NO.	DATE	DESCRIPTION
7	2018/04/04	ISSUED FOR ADDENDUM #2
6	2018/03/23	ISSUED FOR TENDER
5	2018/02/14	ISSUED FOR PERMIT REVISIONS R1
4	2017/12/19	ISSUED FOR BUILDING PERMIT
3	2017/03/22	ISSUED FOR COSTING
2	2017/01/16	ISSUED FOR COORDINATION
1	2016/12/02	ISSUED FOR COORDINATION

PROJECT:
**BROCK MISSION
MEN'S SHELTER**

DRAWING TITLE:
FLOOR PLANS

DRAWING NO:
A-101

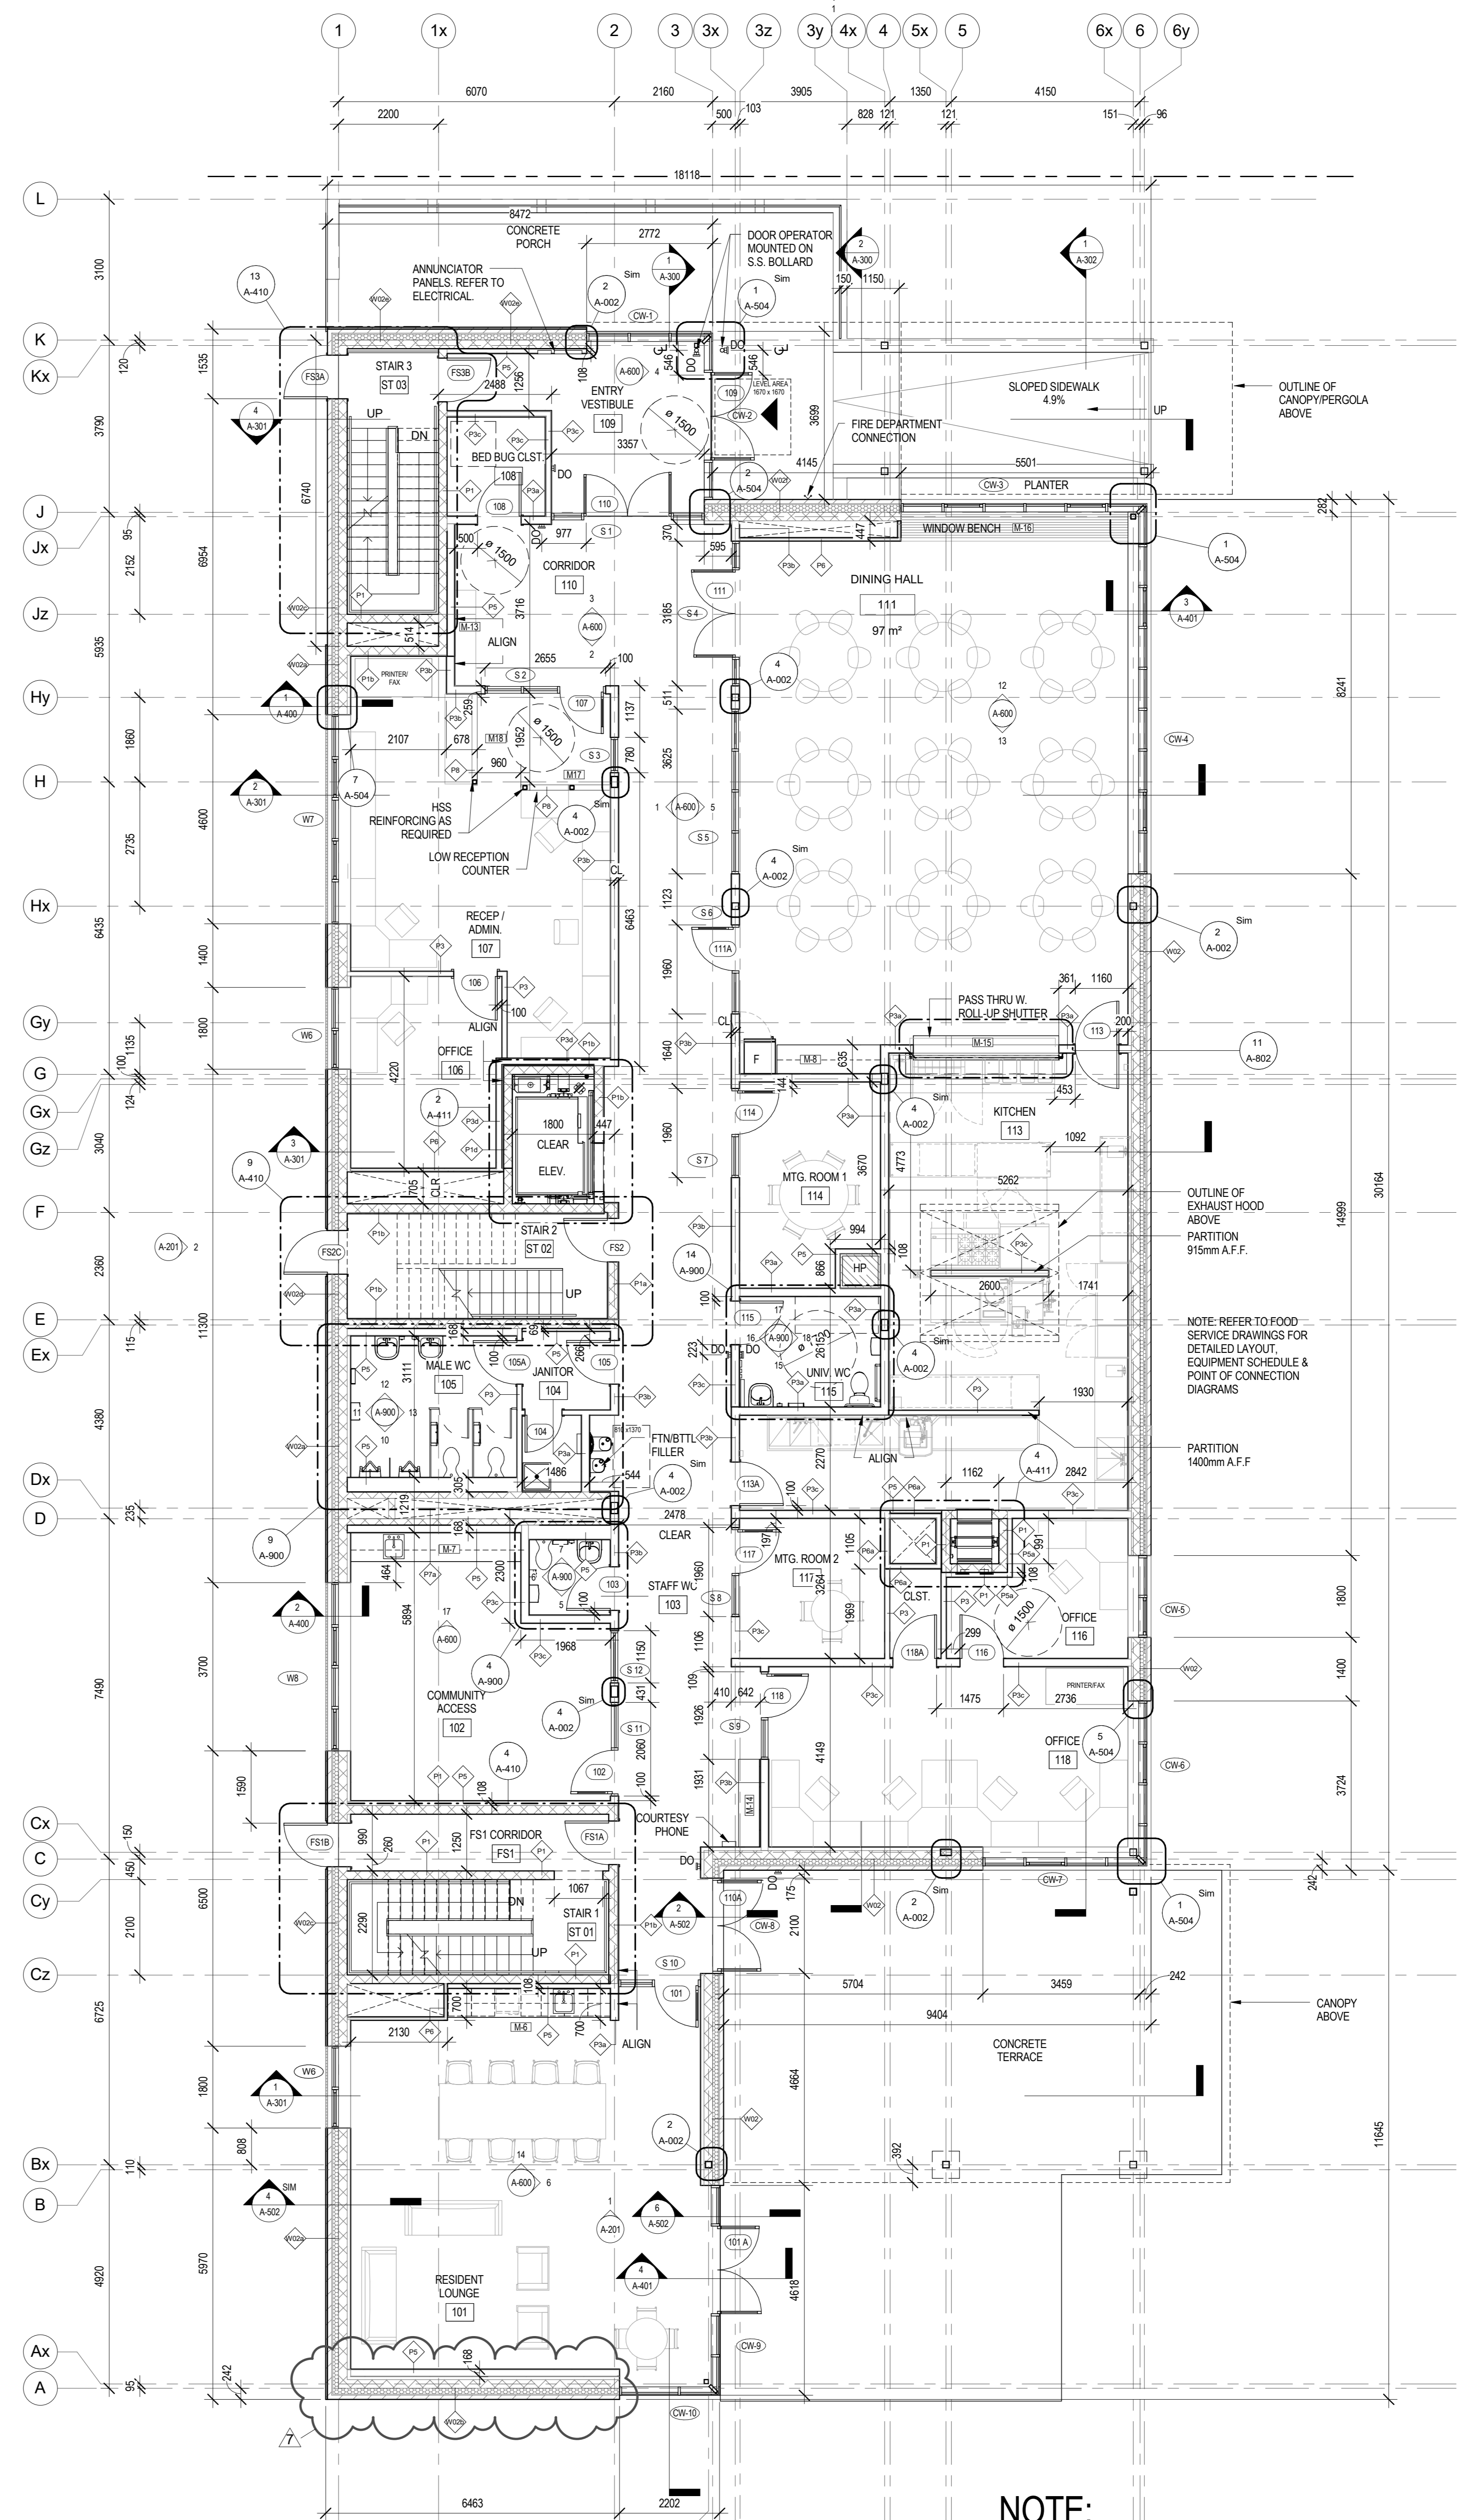
NOTE:
REFER TO ELEVATIONS FOR CHANGE
IN EXTERIOR BRICK ASSEMBLY
